NUMBER: 09-007-04

GROUP: Engine

Irregular Engine Snapping Sound

This bulletin involves chamfering the bore radius on cam bearing caps L2 through L5 and R2 through R5.

Fig. 1 CAMSHAFT BEARING CAP IDENTIFICATION

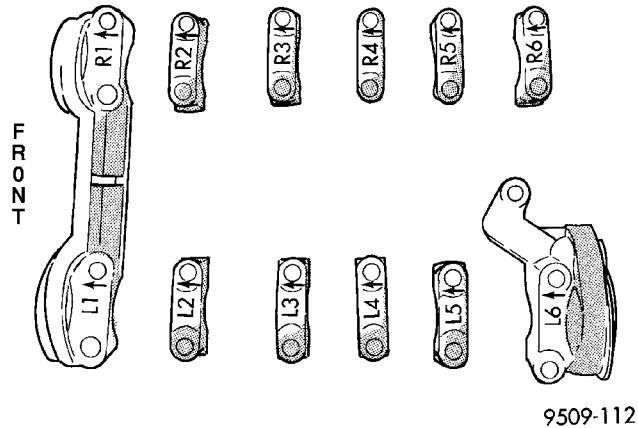
1. Remove the cylinder head cover (Refer to information available in TechCONNECT 9 - ENGINE/CYLINDER HEAD COVER - Removal)
2. Remove L2 cam bearing cap (Fig. 1).

NOTE: Do not remove the #L1/R1 or L6 cam bearing caps, or loosen the fasteners.

NOTE: Only remove one cam bearing cap at a time.

Fig. 2 CAMSHAFT BEARING CAP

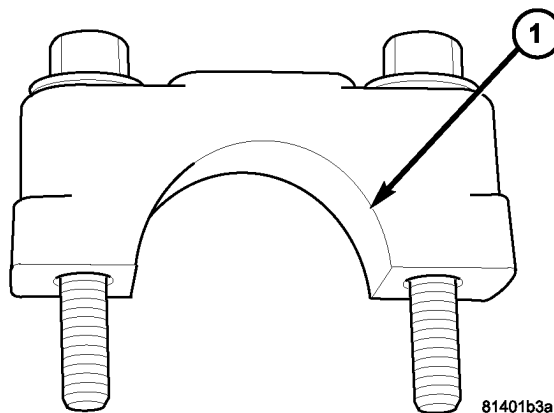
3. Lightly chamfer the two bore radius edges with a small hand file, creating a 45° chamfer 1.0 to 1.5 mm in width along the edge of each bore radius (Fig. 2).

CAUTION: Be careful not to scratch bore surface of cam bearing cap. Chamfer both bore radius.

5. Reinstall L2 cam bearing cap by loosely assembling fasteners. Prior to and during the torquing of each fastener, twist the cam bearing cap by hand in a clockwise direction, as viewed from the top of the engine. Torque M6 fasteners to 12 N·m (105 in. lbs.) while maintaining a clockwise twisting force on the cam bearing cap.
6. Repeat steps 2 through 4 for cam bearing caps L3, L4, L5, R2, R3, R4, R5 and R6.
